COLORADO
Division of Water Resources
Department of Natural Resources

April 26, 2022

**Re: DPG Gravel Pit Substitute Water Supply Plan (WDID 0302587, Plan ID 6243)
DRMS Permit No. M-2019-028 (WDID 0307924)
SE¼ Section 1 and NE¼ Section 12, T5N, R65W, 6th P.M.
Water Division 1, Water Districts 2 and 3, Weld County**

Exhibit 2. Site Map depicting general locations of mining pit (orange) and recharge pond (blue) and Patterson Ditch

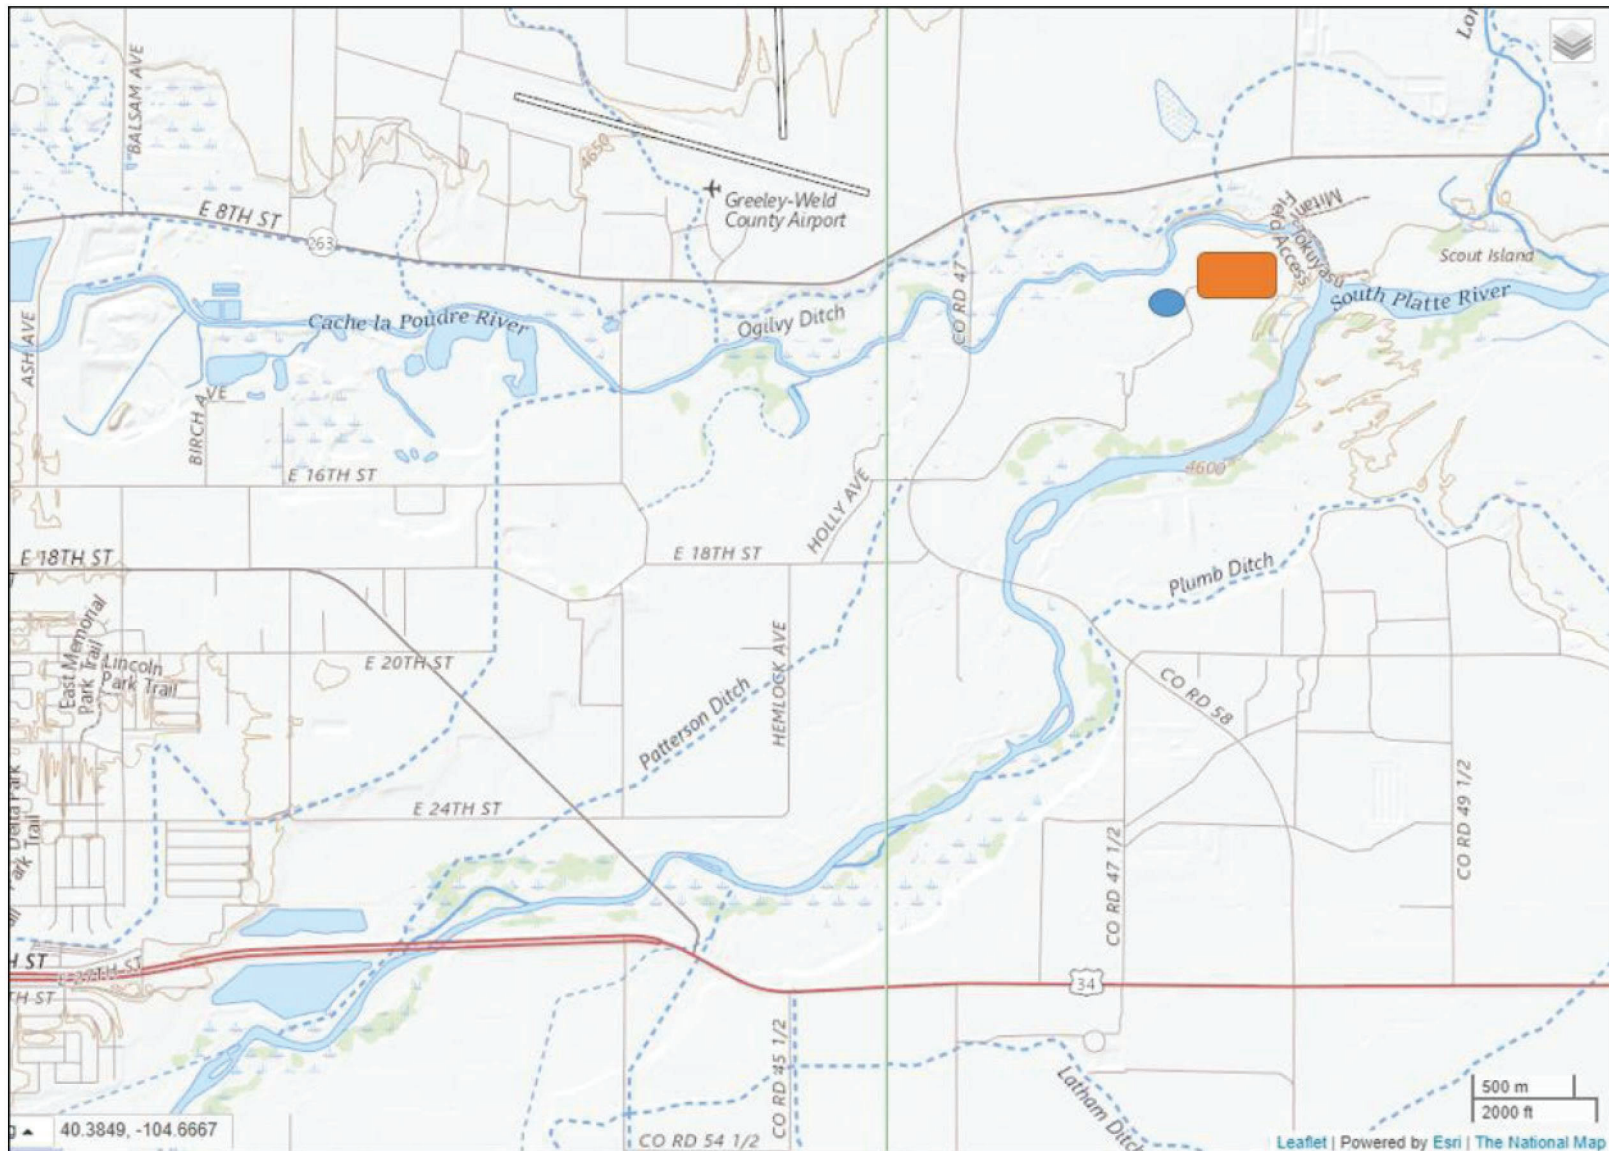
The required dry-up associated with the change of use of the 8 shares is 108.2 acres ($8/15 \times 202.9$ acres). According to the map you provided, 108.3 acres have been dried up as a result of mining operations. Verification of dry-up for the 2022 irrigation season will be provided to the Division Office at the end of the irrigation season.

14. The Applicant shall perform an inspection of the required 108.2 acres of dry-up area, submit a certification of that inspection, and provide a zipped GIS shapefile of the dried-up land as follows:
